HASTINGS GENERATION PROJECT APP009563	DEVELOPMENT LICENCE APPLICATION – EPA REQUEST FOR FURTHER INFORMATION – MAY 2022	
--	---	--

With respect to the Request for Information received from the EPA on the 13 May 2022, Esso provides the following response, taking into consideration:

Figure 2: Predicted Low Frequency Levels at NSR1

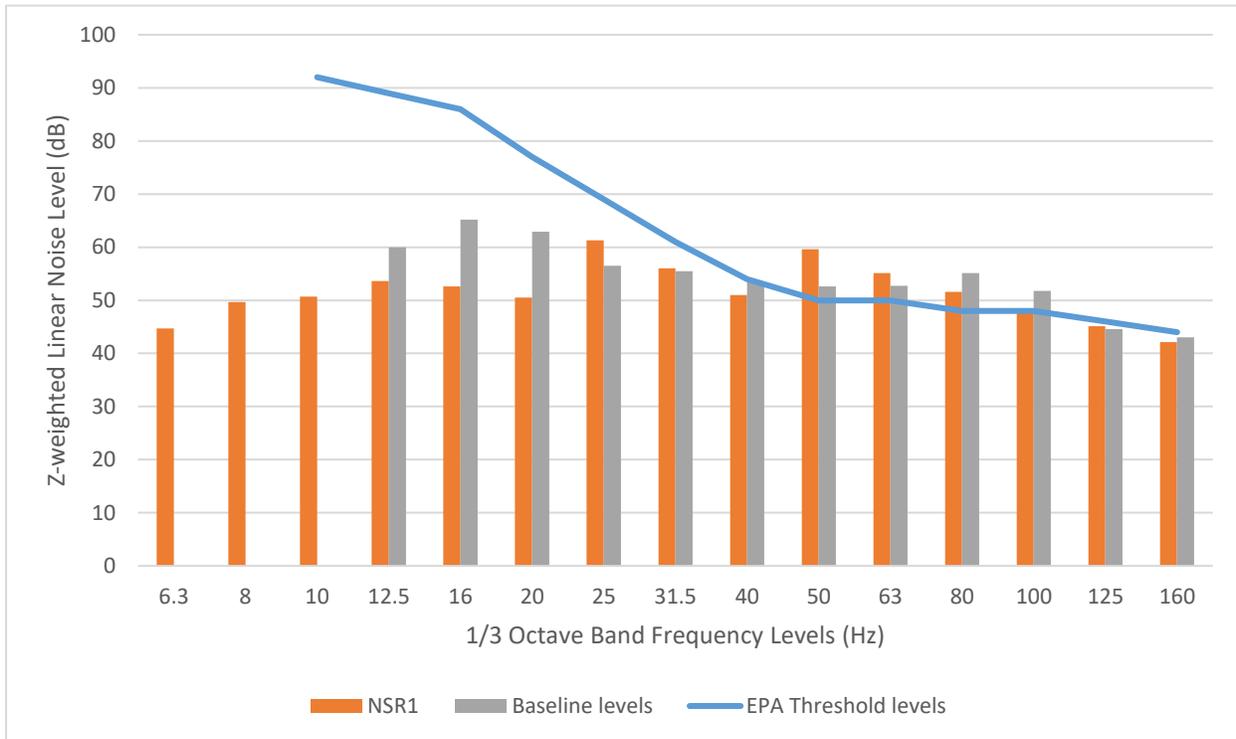
c) Esso Australia Pty Ltd provided responses to community questions on 5 May 2022. Question 1 related to infra sound and the response included an assessment of the low frequency noise for the proposal. In reviewing that information and the application, EPA request that the following is provided: <ol style="list-style-type: none"> i. An assessment of alternative equipment that could be used to minimise the low frequency noise emissions; ii. An assessment of any proposed mitigation measures to reduce the risk of low frequency noise; and iii. Measurements or other information supporting how the modelled impacts of low frequency noise was undertaken.

Exceedances in the 50 Hz, 63 Hz, 80 Hz and 100 Hz bands are predicted. However, the exceedances in the 80 and 100 Hz bands are below the baseline levels measured and are therefore unlikely to be audible. The predicted noise levels from the project at NSR1 in the 50 Hz and 63 Hz bands are approximately 30 dB(A) in each band (refer to *Low Frequency Noise and Infrasound Analysis* (Attachment C)). Predicted noise in the 63 Hz band is within 3 dB of current baseline levels and it is therefore unlikely that the increase in noise in this band will be audible. Received noise levels in the 50 Hz band are likely to be only faintly audible.

Baseline levels exceed the guideline thresholds for the 50 Hz, 63 Hz, 80 Hz, 100 Hz and 125 Hz bands.

Fluctuating sounds are known to be a more disturbing than steady sounds [6], and therefore it was suggested by Defra that the threshold for continuous sounds, likely to be emitted from the HGP, should be relaxed by 5 dB.

There are no exceedances below 50 Hz, especially in the infrasound range (< 20 Hz). It is not anticipated that there will be any significant infrasound from the project.
